Product change notification (PCN)

Title / short description	Update of approvals for the PLC-INTERFACE product portfolio for use in potentially explosive atmospheres
Affected article category	Relay modules
Change category	Marking, Approval
Change number	CDK250063-00
Reason for PCN/PDN Revision

Update of approvals for the PLC product portfolio for use in potentially explosive atmospheres

CDK250063

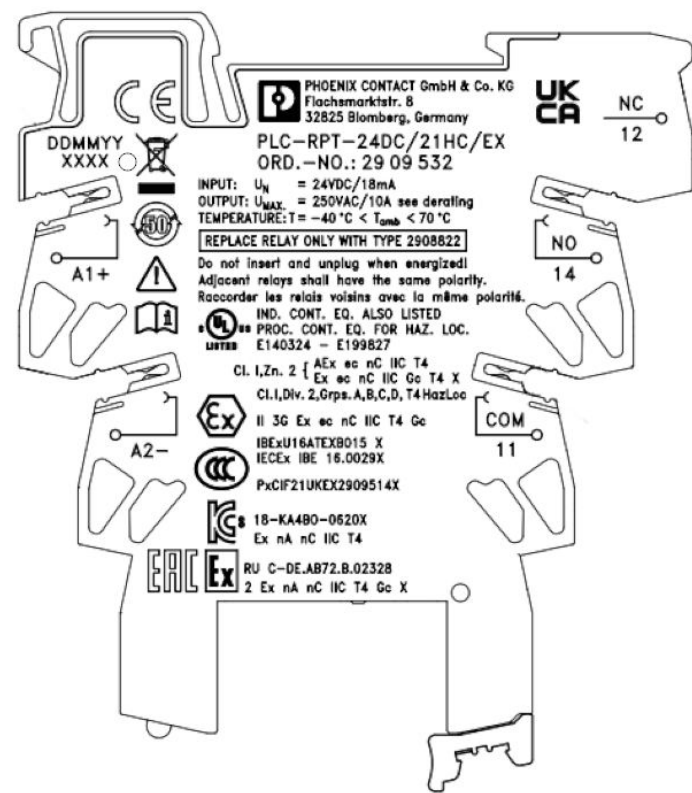
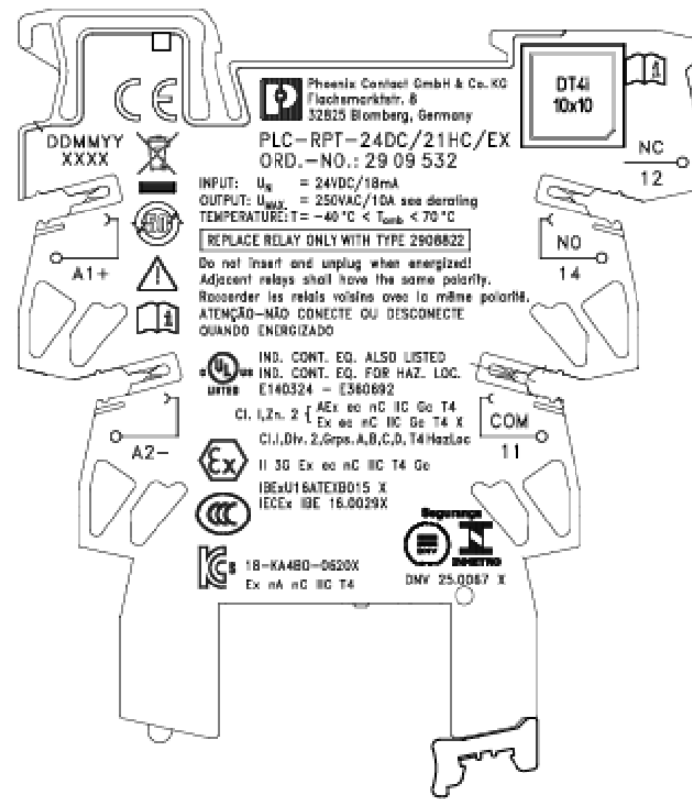
The approval status of the PLC - INTERFACE product portfolio for use in potentially explosive atmospheres has been revised (see list). As part of the update, the EAC approval will be removed, and the UKCA logo will no longer be printed on the products. In addition, a new certification according to the Brazilian InMetro standard has been obtained.

Due to the update of the UL HazLoc approval, a new standard now applies. UL 60947, instead of the previous UL 61010.

The previous marking text:

"Industrial Control Equipment

ALSO LISTED Process Control Equipment for Hazardous Locations

E140324 E199827"

will change to:

"Industrial Control Equipment

ALSO LISTED Industrial Control Equipment for Hazardous Locations

E140324 E360692".

This results in a change of the certificate number (E File). These changes require updates to the product marking, the printed information in the packaging leaflet, and the certificates provided in the e shop. A comparison of the new and current product marking is provided in the attachment.

Additionally, the items will also be updated with the QR Code. The new QR code links directly to the product's Digital Twin, providing centralized and easy access to all relevant documentation, technical data, certificates, and declarations of conformity.
